EAST VILLAGE  
Preliminary Development Plan Phase 2  
Lots 14-22 & Tracts C, E-G  
Section 8, Township 47 North, Range 31 West  
LEE'S SUMMIT, JACKSON COUNTY, MISSOURI

Preliminary Development Plan

PRELIMINARY DEVELOPMENT PLAN  
Preliminary Development Plans for:  
East Village  
Lee's Summit, Jackson County, Missouri

**FIRE HYDRANT PLAN PHASE 2**

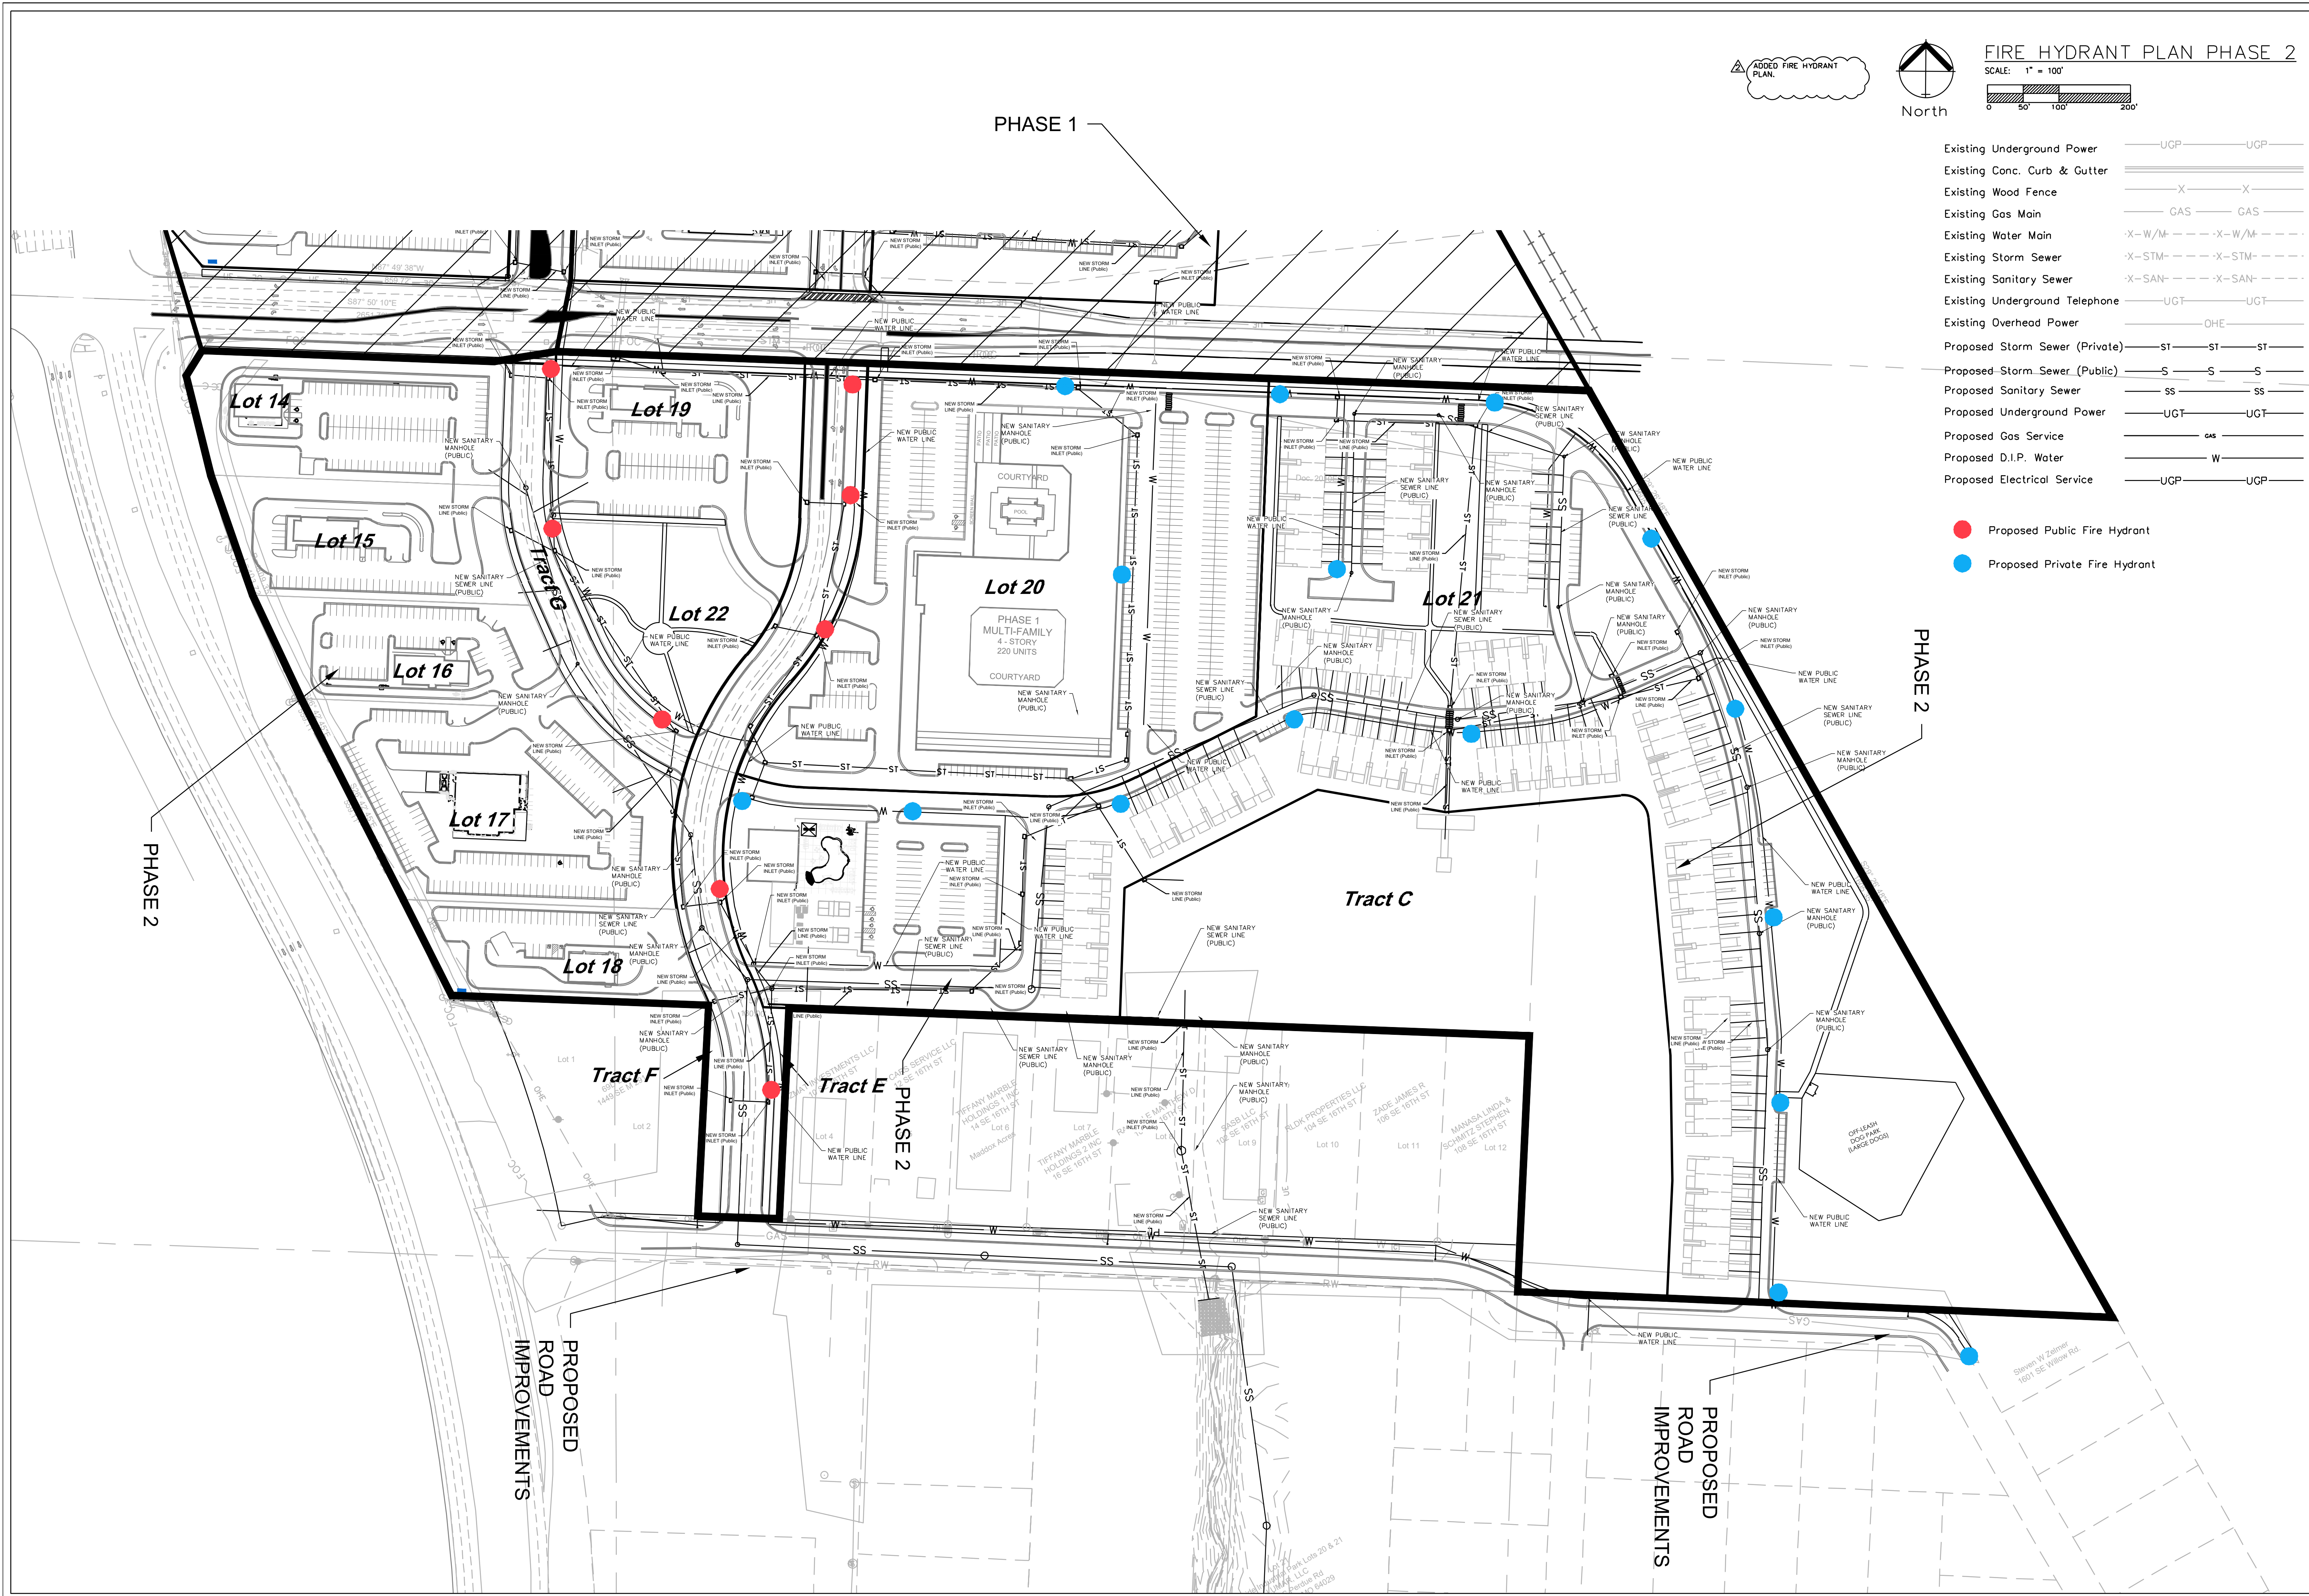
ADDED FIRE HYDRANT PLAN.
